ADDENDUM 1
Rockingham County Four-Bay Salt Storage Building
Wentworth, NC SCO ID# 09-07377-011
July 28, 2014

PLAN SHOWING
**ELEVATIONS ON
PROPOSED SALT
STORAGE SHED**
JULY 25, 2014
SCALE: 1" = 20'

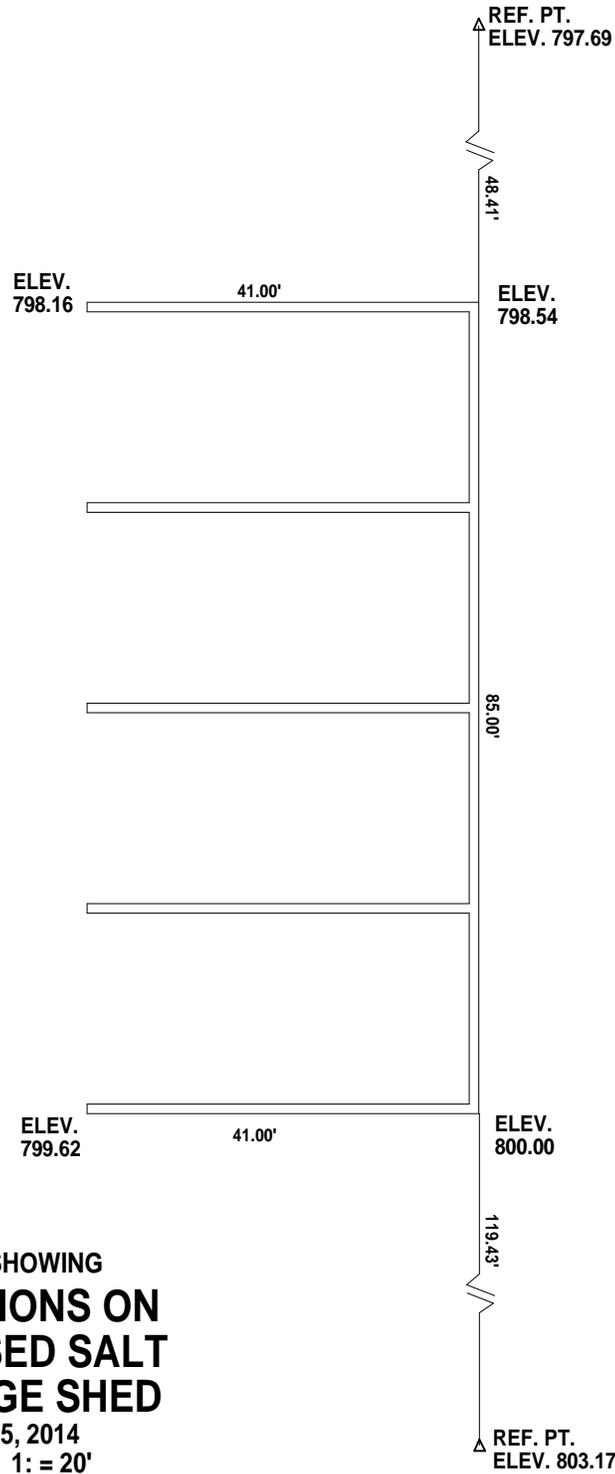
6. *Re: 1/S2 – No top of footing elevation is shown. No depth dimensions are shown on S3. The sloped site was discussed at the pre-bid meeting. Please provide existing surface grades and top of footing elevations.*
Top of footing elevation was noted on S2 plan notes as -1'-0" below asphalt. However, that has been changed to reflect slope of site. The foundation plan and front elevation have been revised to reflect footing steps and elevations. See attached sheet for elevations taken at the building site.

- Item 4: **Please see the attached plan showing existing spot elevations of the four building corners.** The building corners have also been marked by NCDOT personnel during measurement of the elevations.
